# Planning Commission Meeting

Consideration of a Preliminary Plat application for the Harmony Ridge Plat "J" subdivision consisting of 51 lots in the Planned Development (PD-3) zone.

**HARMONY RIDGE - PLAT J FINAL**

## Development Review Committee Minutes

1 | RPZ BACKFLOW CROSS CONNECT DETAIL

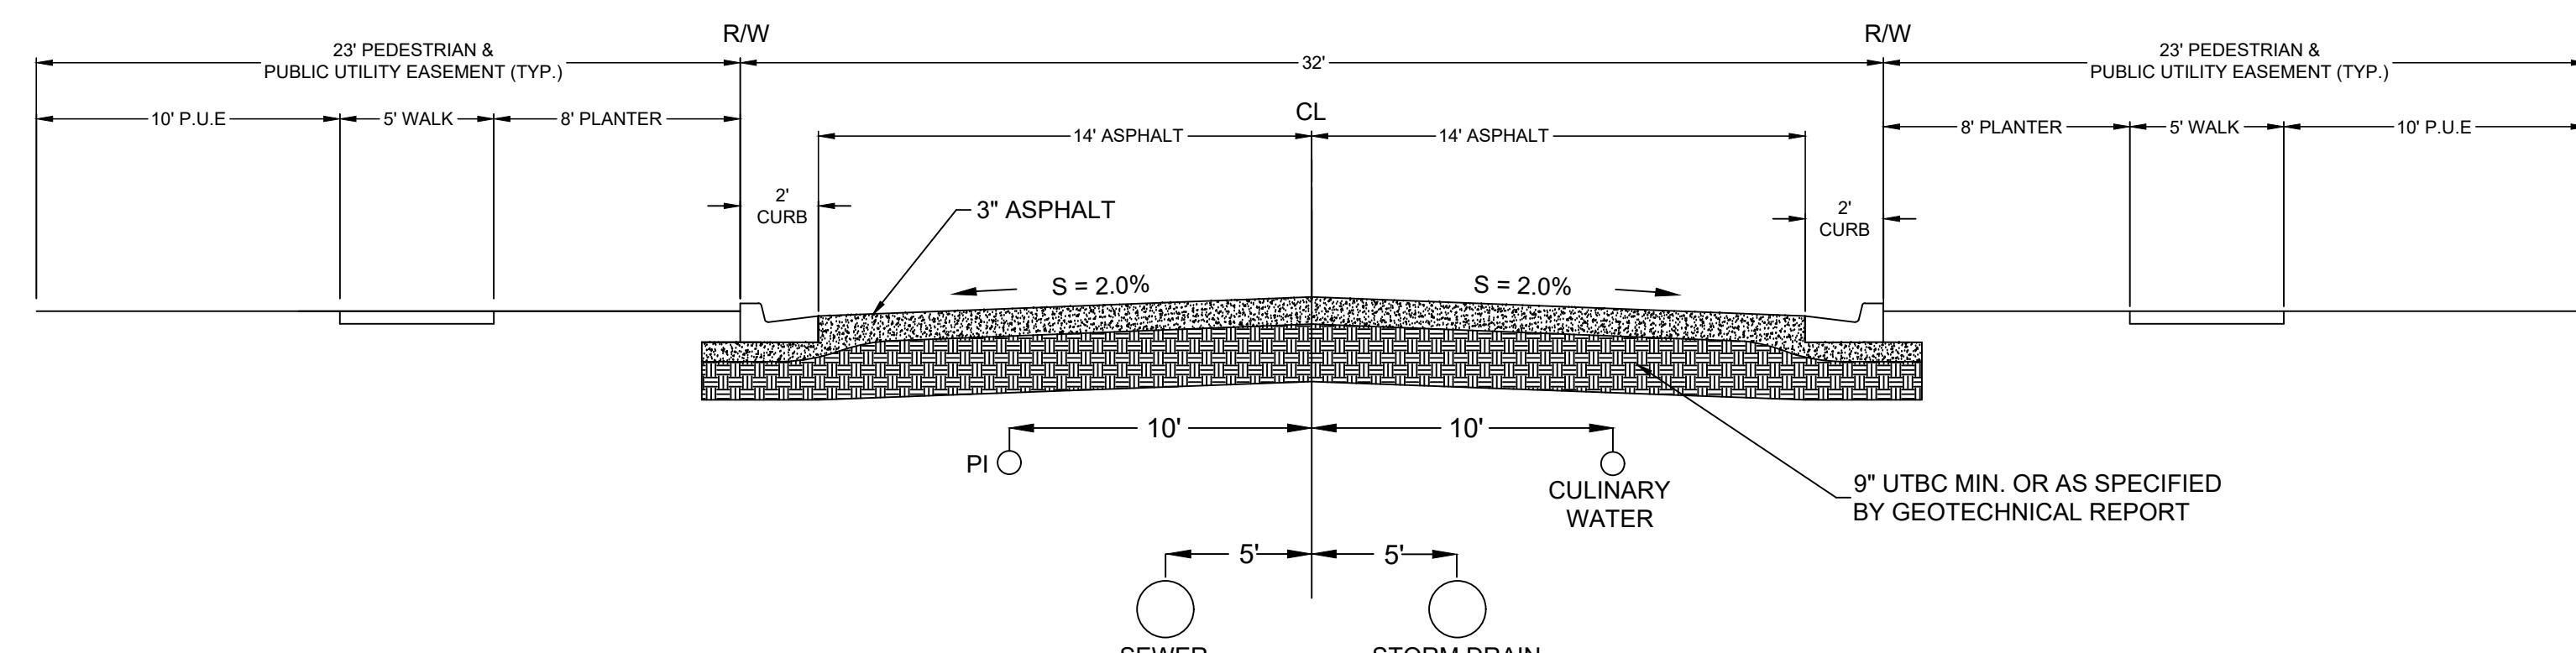
1. Include a note on sheet 403 to install a blind flange on the abandoned RPZ tee.
  - a. Update the RPZ detail to show gravel being installed directly underneath the RPZ to allow for proper drainage when the RPZ needs to be drained.

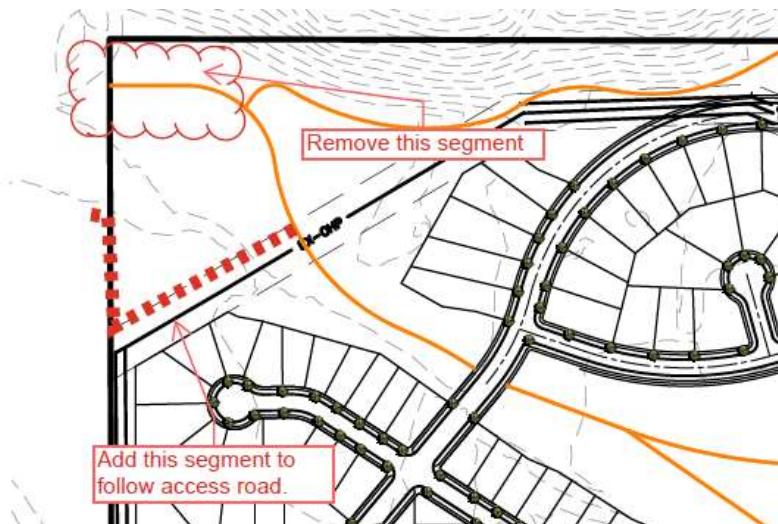
1. As these phases for Harmony Ridge continue closer to the foothills of the mountains, it might be time to consider analyzing the 2 canyons that appear to slope down to the Harmony Ridge development (see attached image below). We just want to avoid a potential situation that Provo found themselves in a few months ago. Can we have you do an analysis on potential debris flows from these two canyons?
